Project Number: SP2019-007
Project Name: Lake Pointe Church
Project Type: SITE PLAN
Applicant Name: HALFF ASSOCIATES
Owner Name: LAKE, POINTE BAPTIST CHURCH
Project Description:

Type of Review / Notes	Contact	Sent	Due	Received	Elapsed Status	Remarks
With this Site Plan following an administrative review for a parking lot, the following staff comments are to be addressed prior to the release of any building permit						
The following staff comments are to be addressed and resubmitted at your convenience. These comments are considered to be conditions of approval. Please provide three large copies [24" X 36" FOLDED] and one PDF version for a subsequent/final review by staff:						
General Comments:

LAKE POINTE CHURCH
PARKING LOT EXPANSION
 701 Interstate 30 Rockwall, TX 75087

**SITE PLAN
LAKE POINTE CHURCH
PART OF LOT 3, BLOCK A
CITY OF ROCKWALL
ROCKWALL COUNTY, TEXAS
MARCH, 2019**

C1.02
Sheet Number

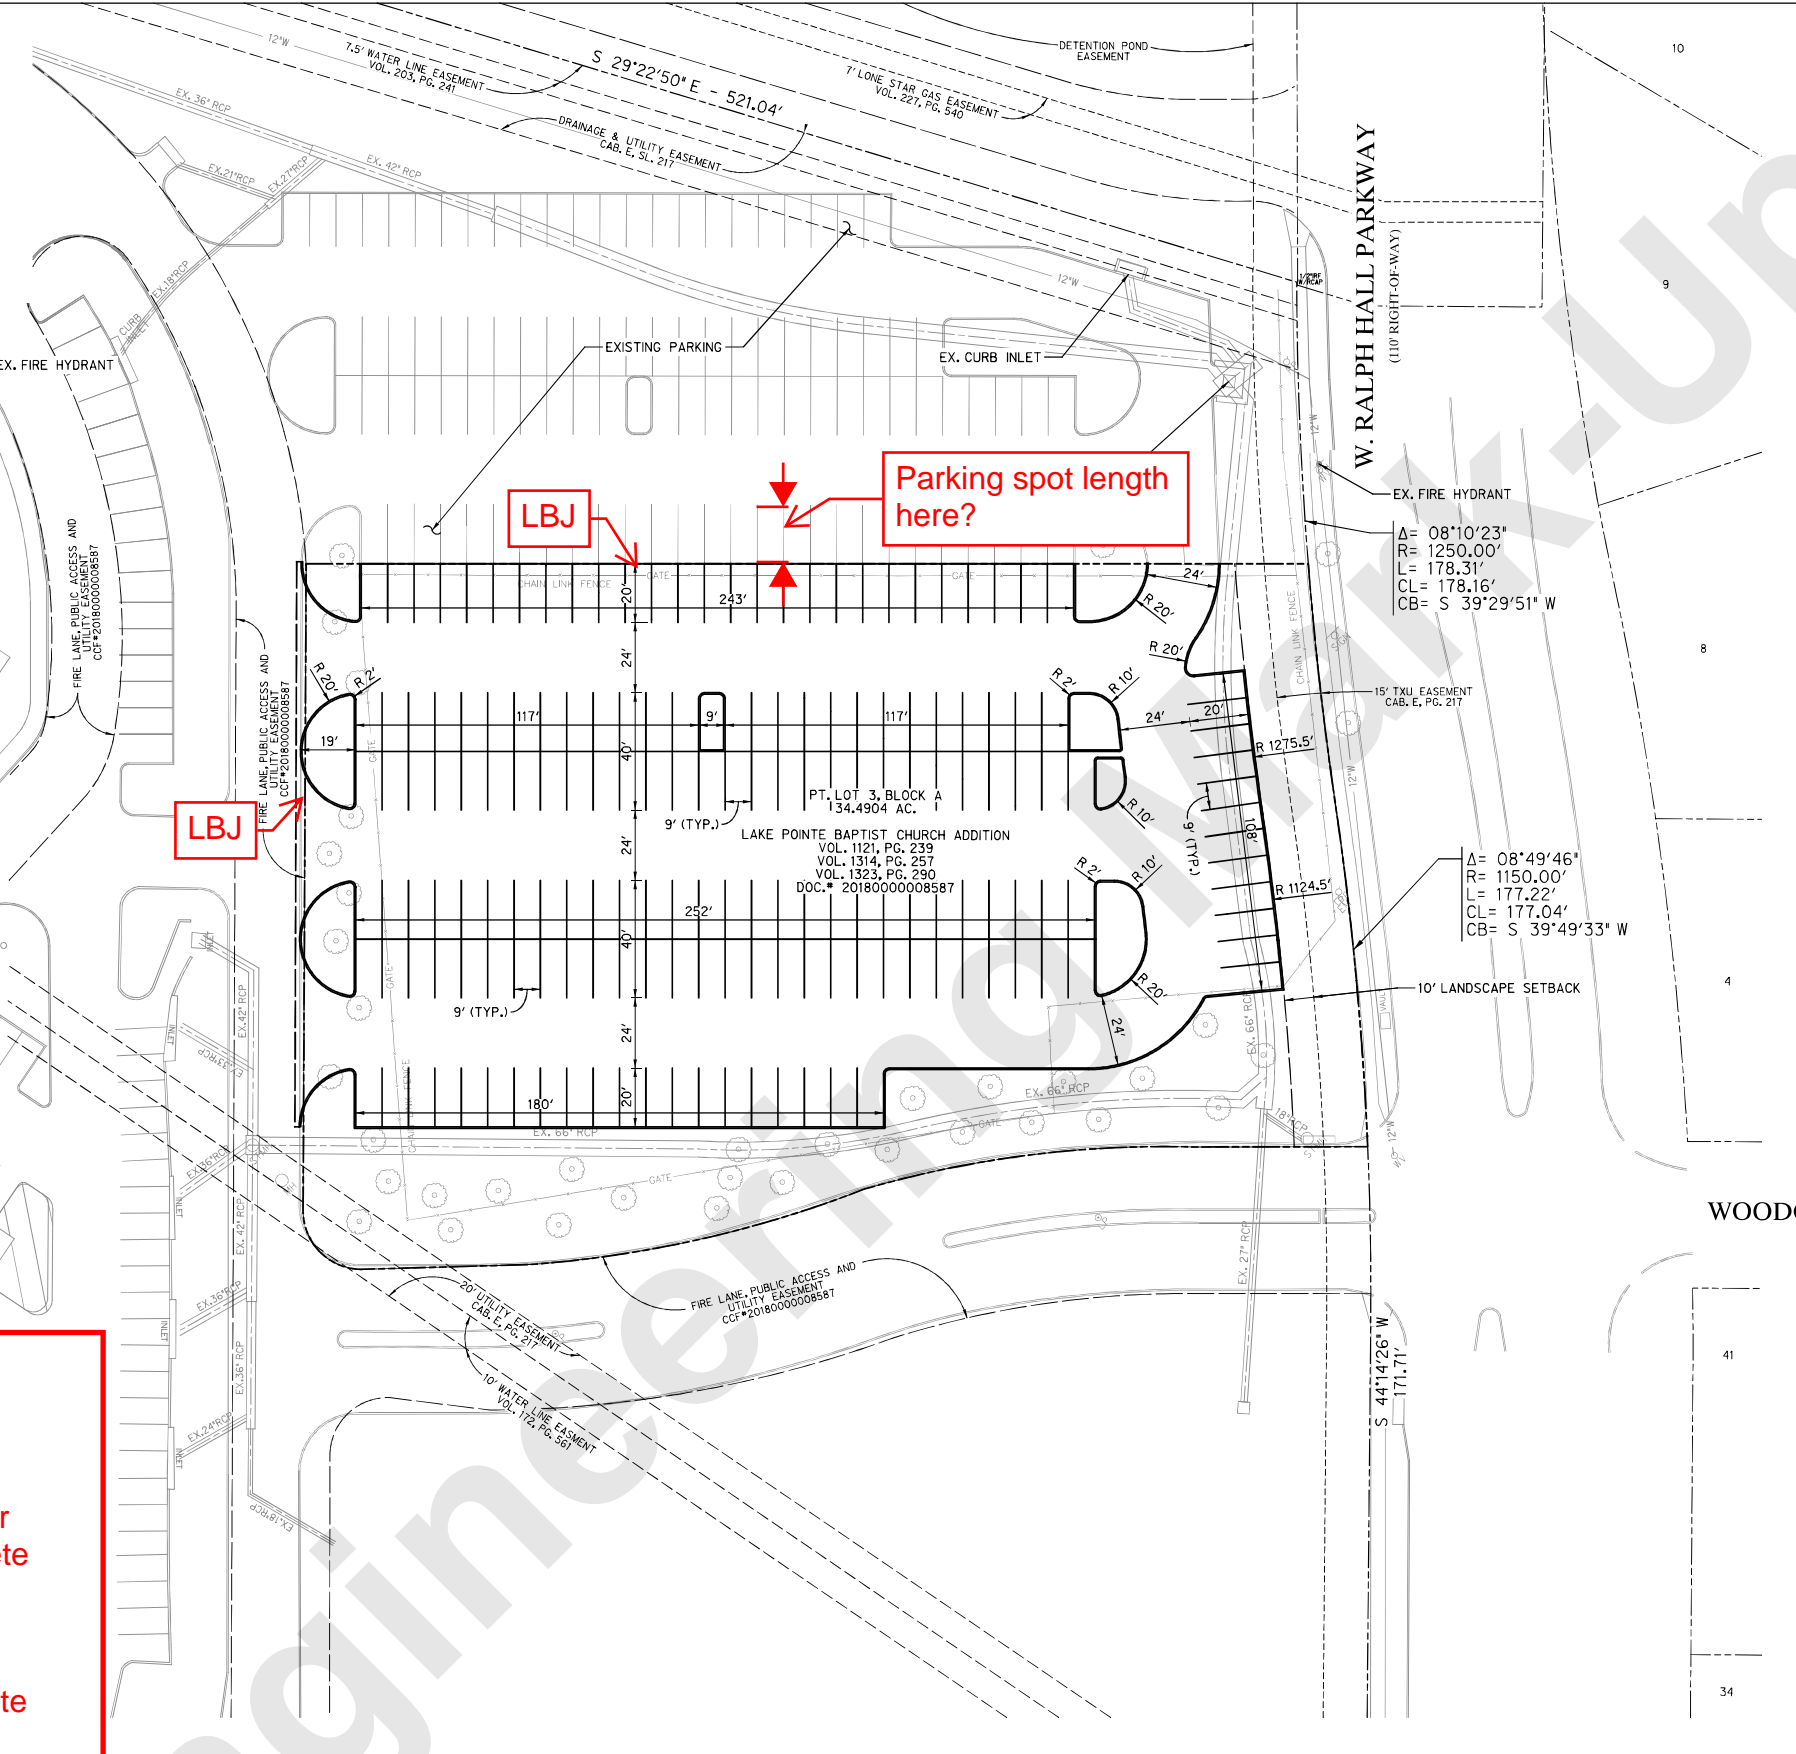
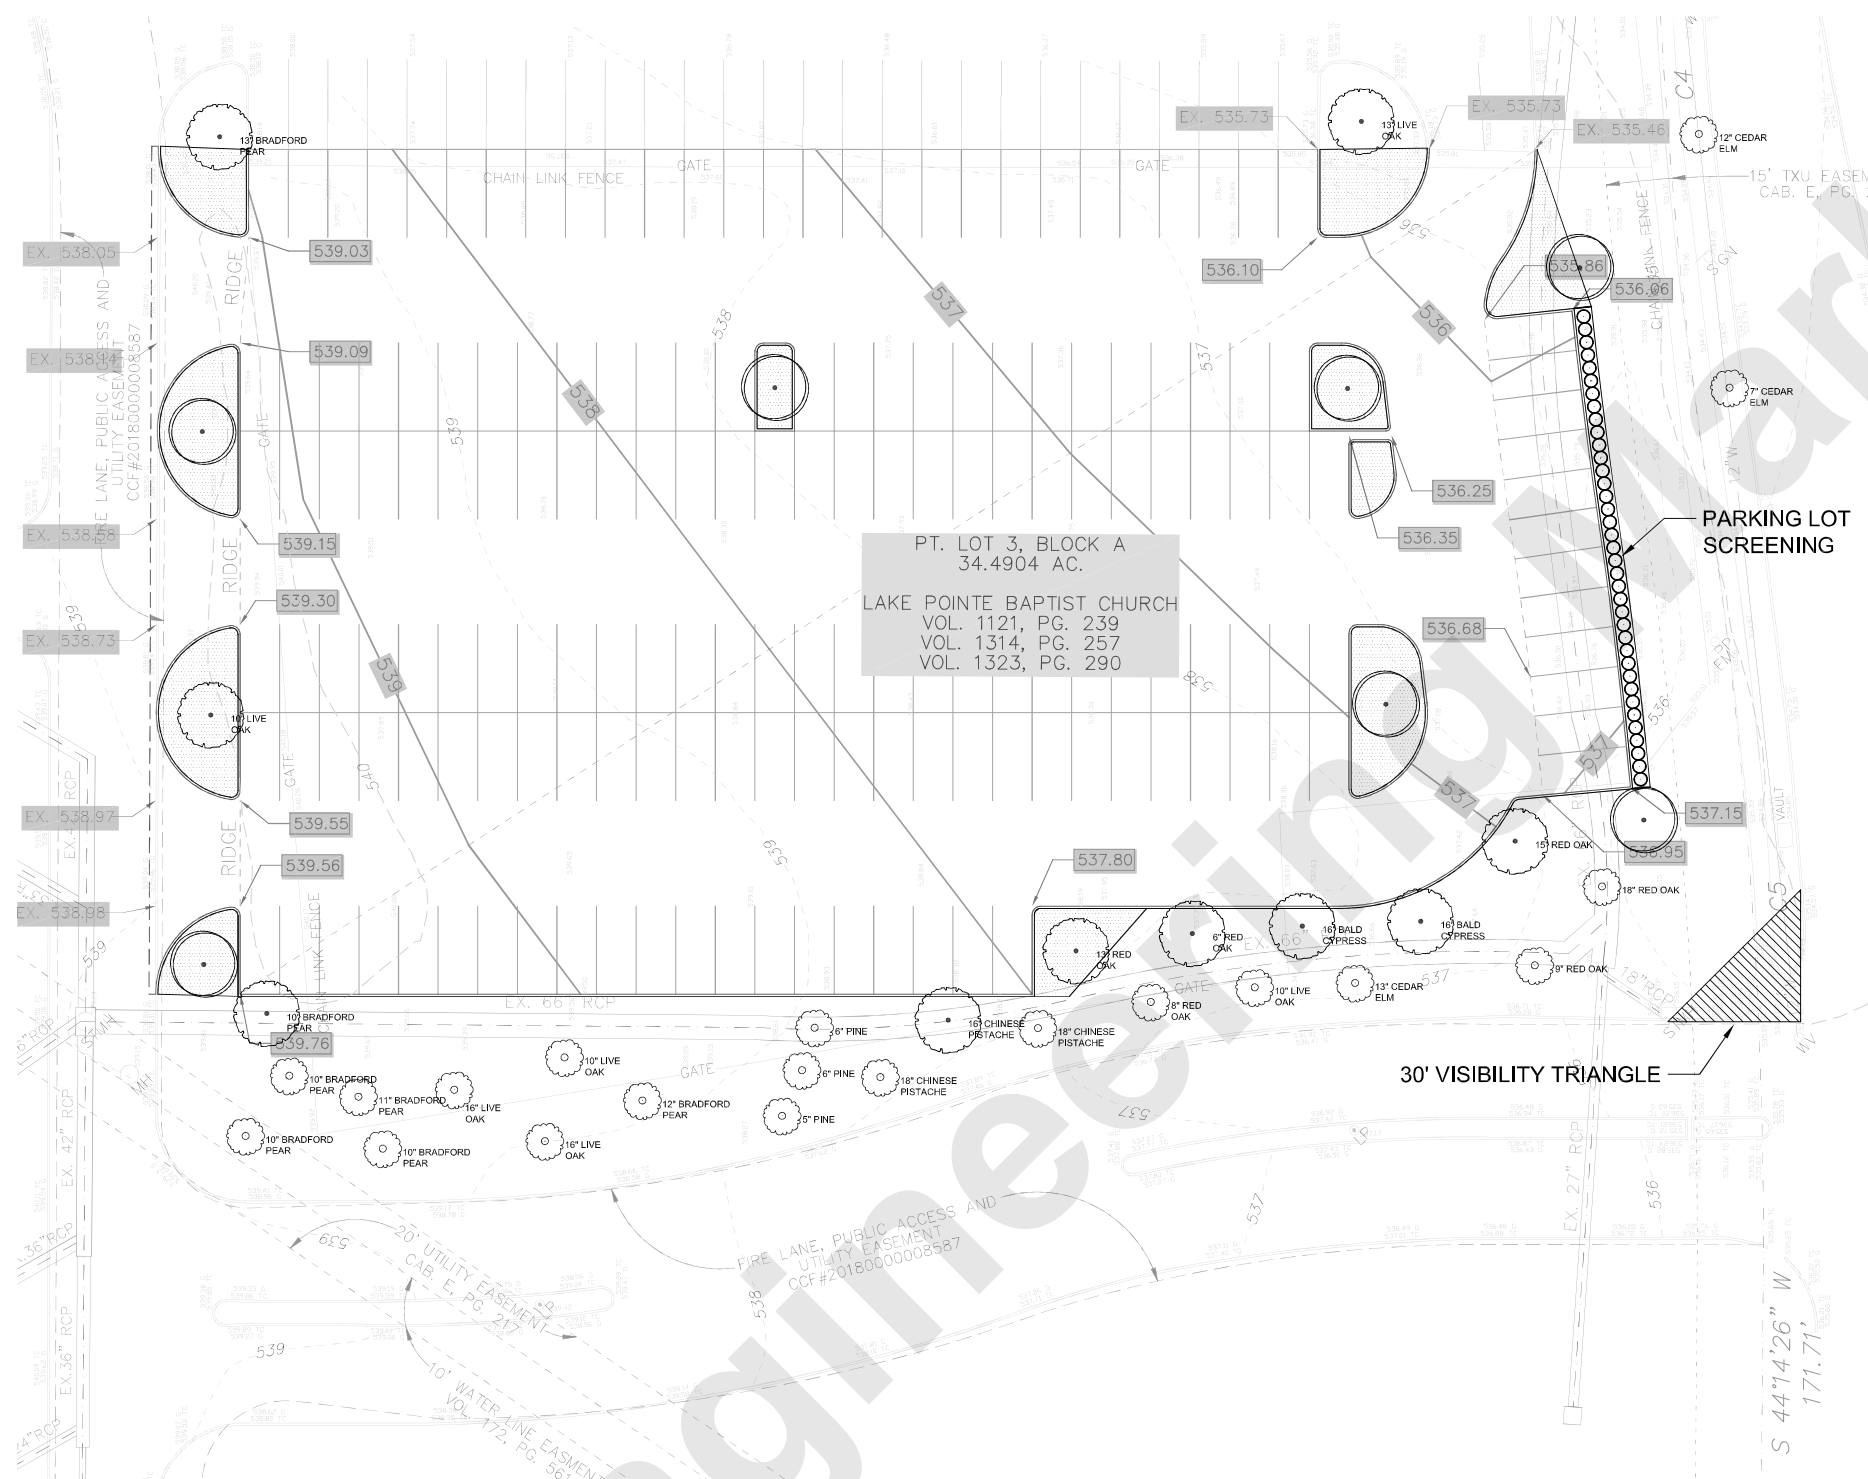
1. Sheet C1.02: Delineate and label existing sidewalk along Ralph Hall Parkway.						
Landscape Plan:						
1. Sheet L1.01: Ghost in all existing trees to better delineate new plantings for site.

Project No.:	35866
Issued:	03.14.19
Drawn By:	MAW
Checked By:	KMW
Scale:	1:20
Sheet Title	LANDSCAPE PLAN
Sheet Number	L2.01

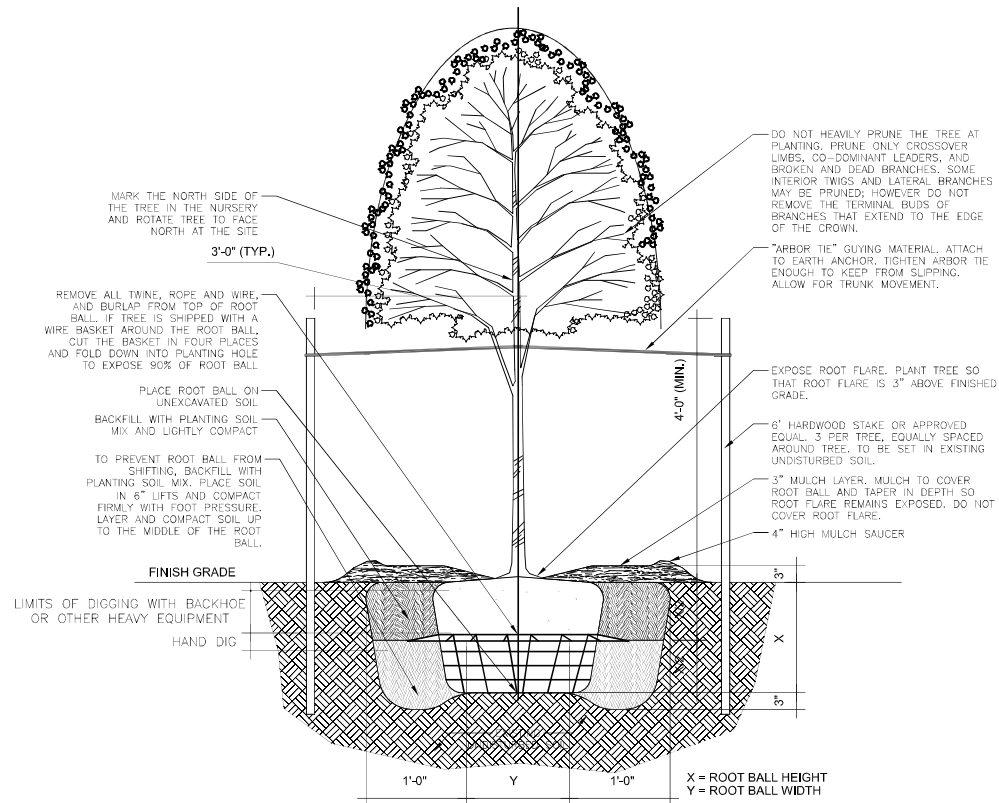
2. Sheet L2.01: Ghost in all existing trees to better delineate new plantings for site.						
3. Sheet L2.01: Indicate all new tree plantings that count toward mitigation (e.g. labeled on sheet L1.01).

Add note, "No trees within 5' of utilities."

NOTE: NO TREES WITHIN 5' OF EXISTING UTILITIES

L3.01
Sheet Number

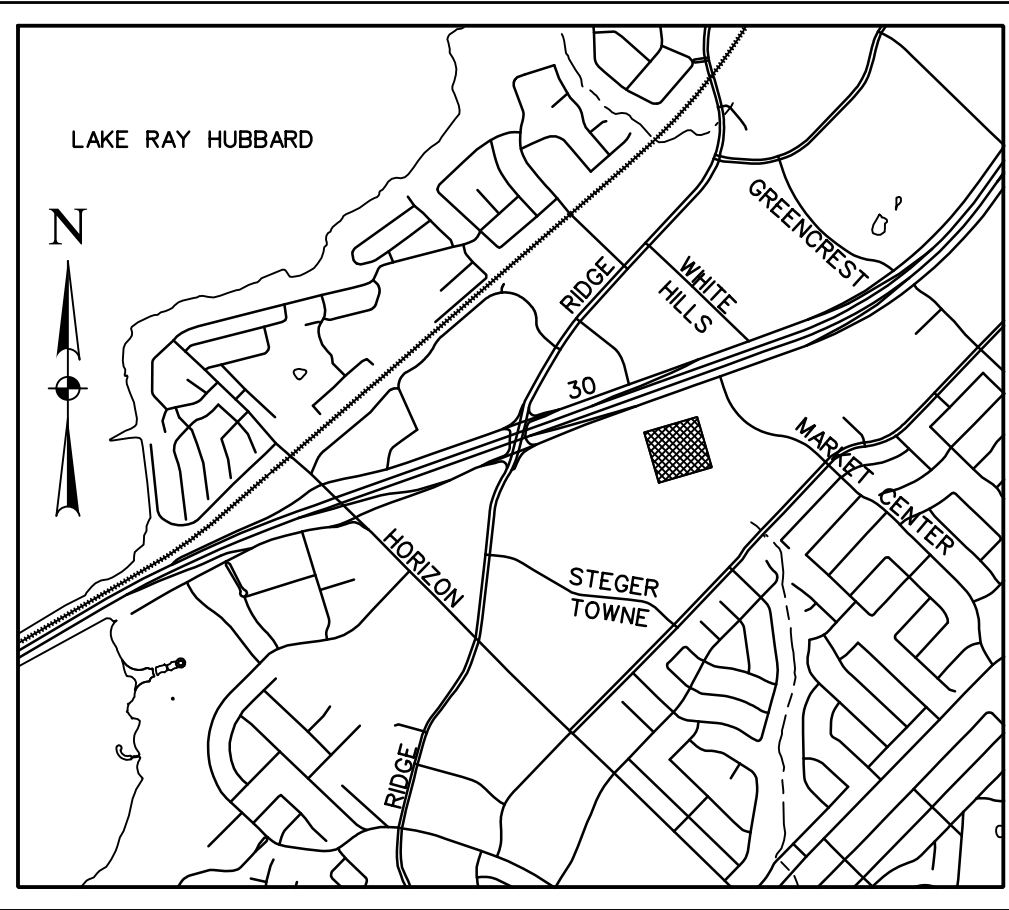
Add note, "No trees within 5' of utilities."

NOTE: NO TREES WITHIN 5' OF EXISTING UTILITIES
